PETITION FOR SPECIAL EXCEPTION

DESCRIPTION TO ACCOMPANY
SPECIAL EXCEPTION FOR
ROADSIDE FARMERS MARKET
MARYLAND ROUTE 30, UPPERCO, MARYLAND

PLAT TO ACCOMPANY
ZONING VARIANCE &
SPECIAL EXCEPTION FOR
FARMERS CO-OP ROADSIDE STAND
~~ROADSIDE FARMERS MARKET~~
HANOVER PIKE - UPPER CO. MARYLAND
4TH ELECTION DISTRICT BALTIMORE COUNTY, MD.
SCALE: 1" = 50' DATE: NOVEMBER 4 1985
REVISED 1-14-86 - ADDED ZONING VARIANCE IN TITLE ADDED MEANING IN ITEM N1
REVISED 2-7-86 - REV. LAYOUT TO ACCOMMODATE S.H.A. COMMENTS OF JAN. 9, 1986
HEARING CASE NO. 86-300 XA ITEM NO. 181

Re: Revised Comments
ZAC Meeting of 11-19-85
ITEM: #181.
Property Owner: Lippy Brothers, Inc.
Location: Centerline of Hanover Pike, Route 30, 1080' S. of Fringer Road
Existing Zoning: R.C. 2
Proposed Zoning: Variance to permit a crushed stone paving area in lieu of a durable and dustless surface (tar & chip) and a Special Exception for a farmers co-op roadside stand in an R.C. 2 zone
Acres: 8.7968
District: 4th

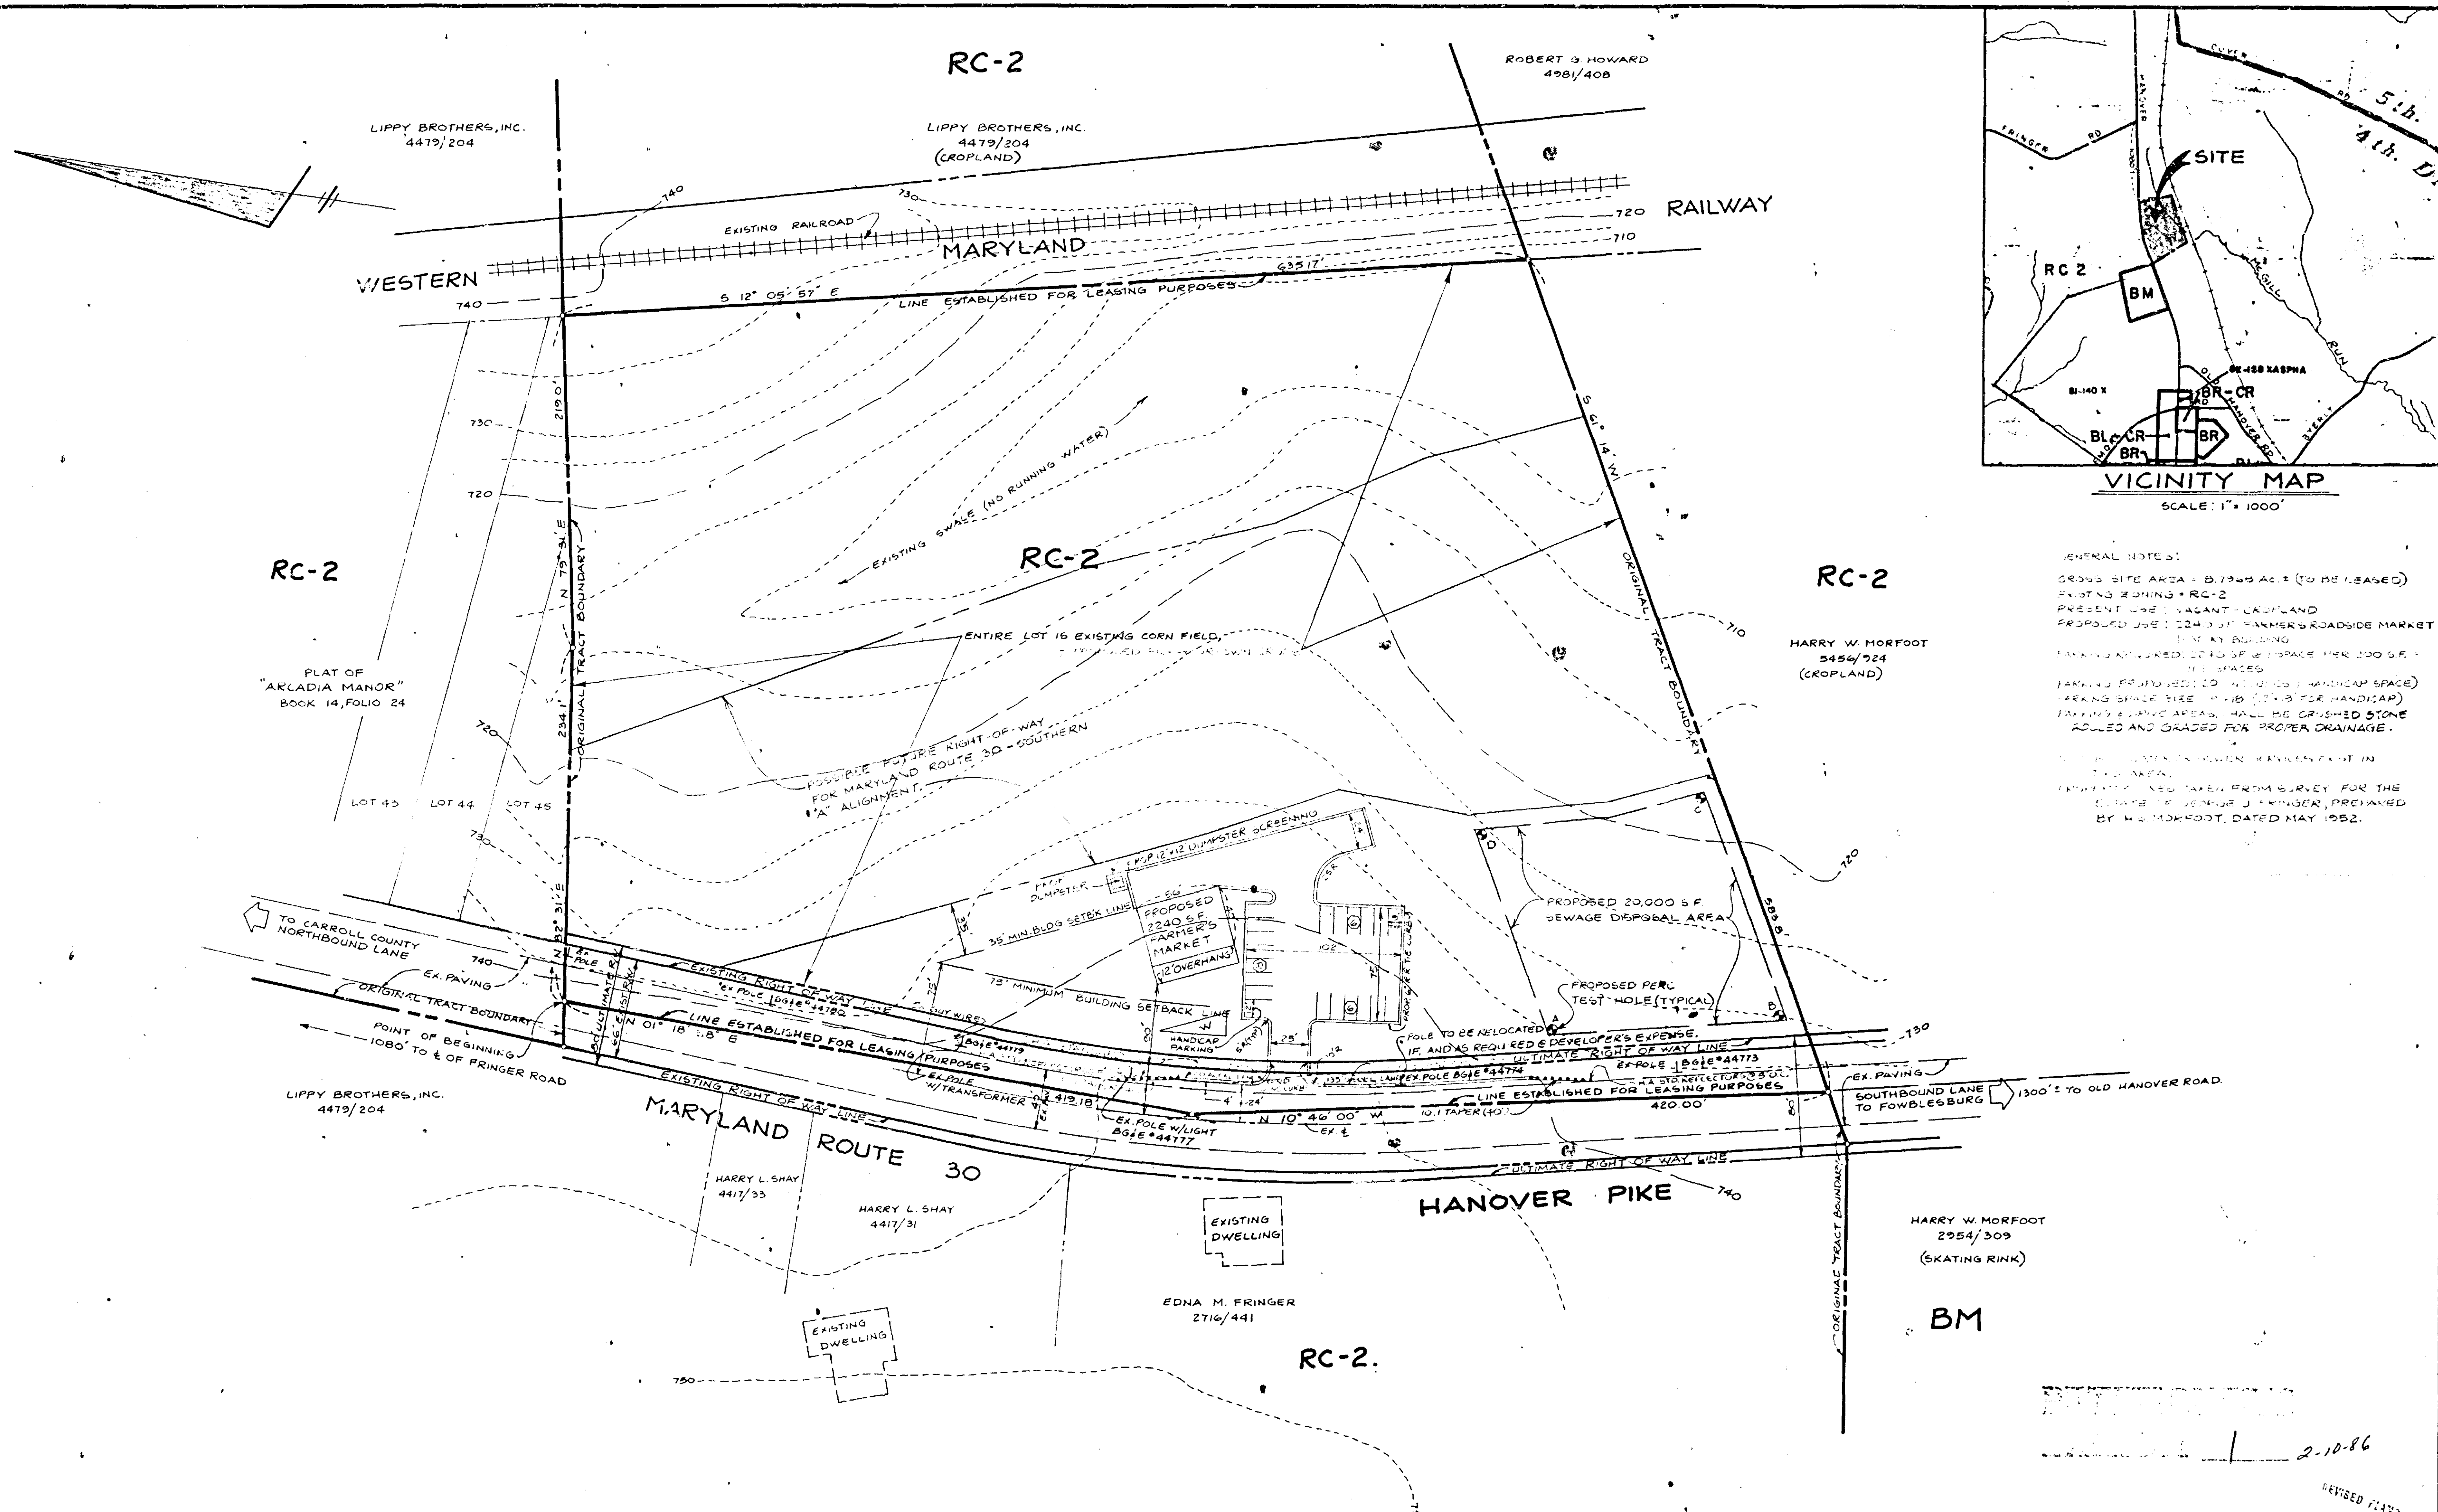
The State Highway Administration's Bureau of Engineering Access Permits will require revisions to the site plan.

The proposed deceleration lane south of the proposed entrance must be revised to show a 135' full width section with a 10:1 taper to meet the existing edge of roadway, and the proposed building relocated outside the proposed Right-of-Way.

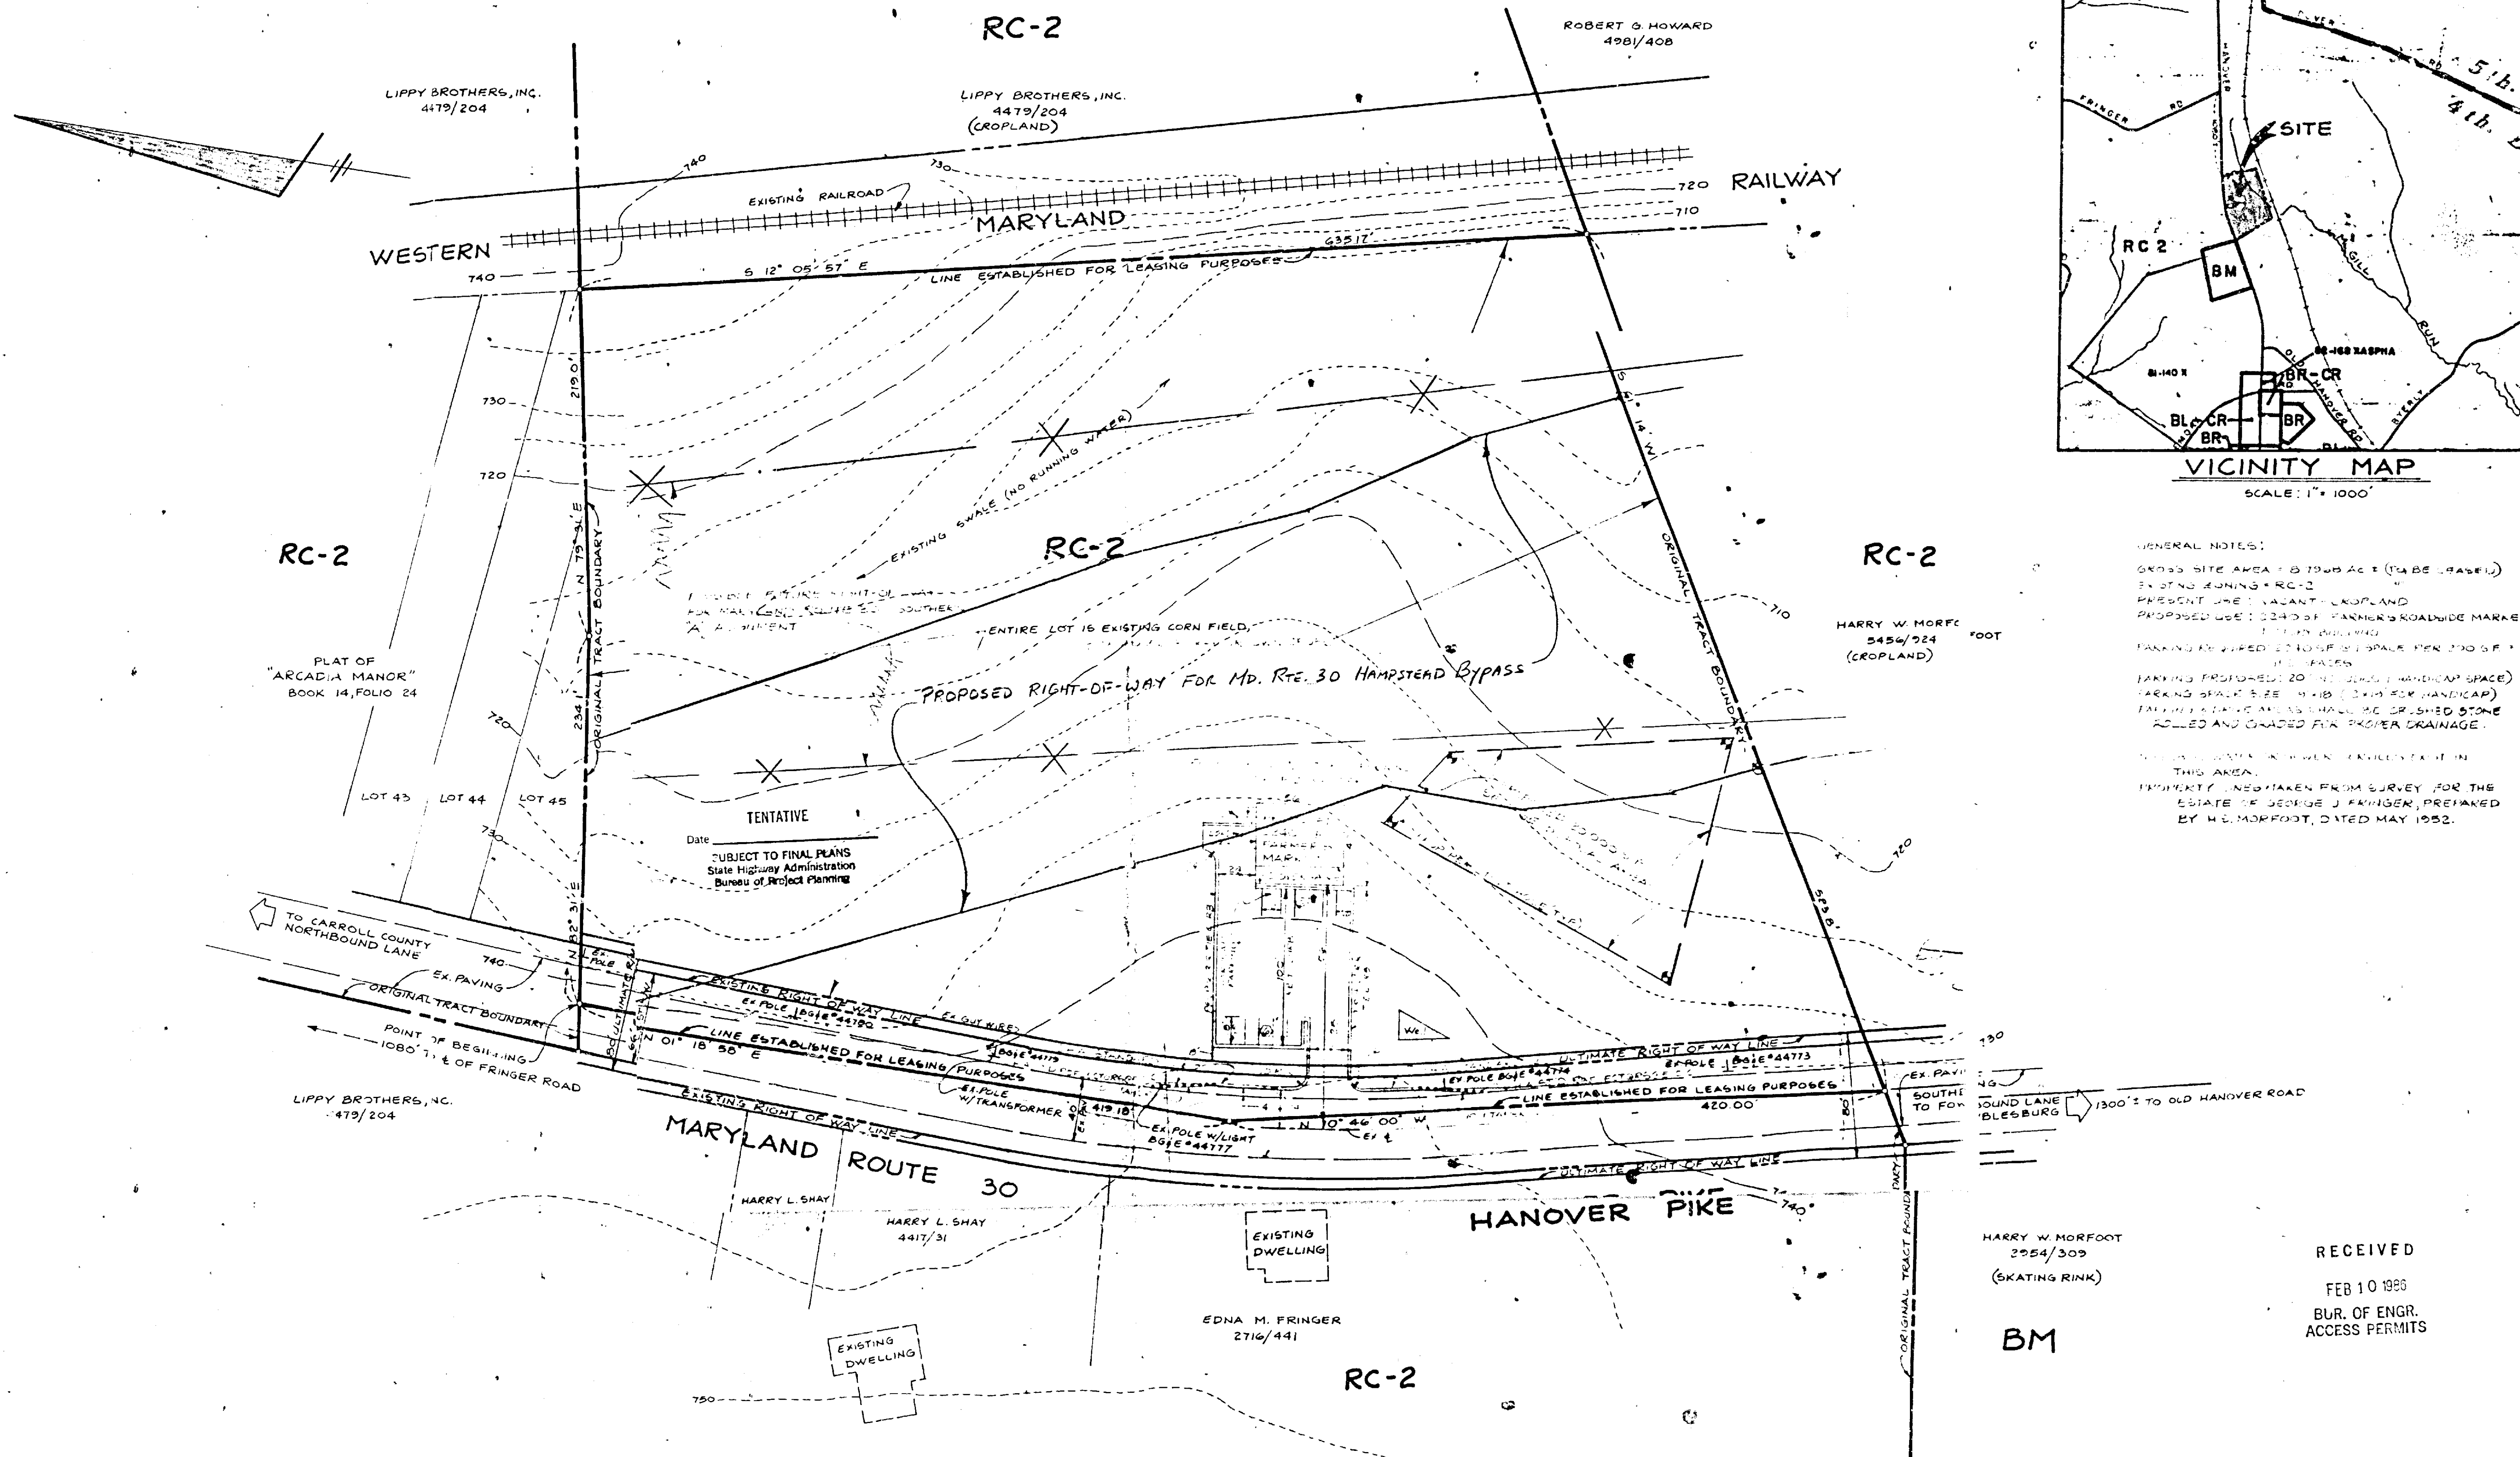
The State Highway Administration's Bureau of Engineering Access Permits will require revisions to the site plan.

The proposed deceleration lane south of the proposed entrance must be revised to show a 135' full width section with a 10:1 taper to meet the existing edge of roadway, and the proposed building relocated outside the proposed Right-of-Way.
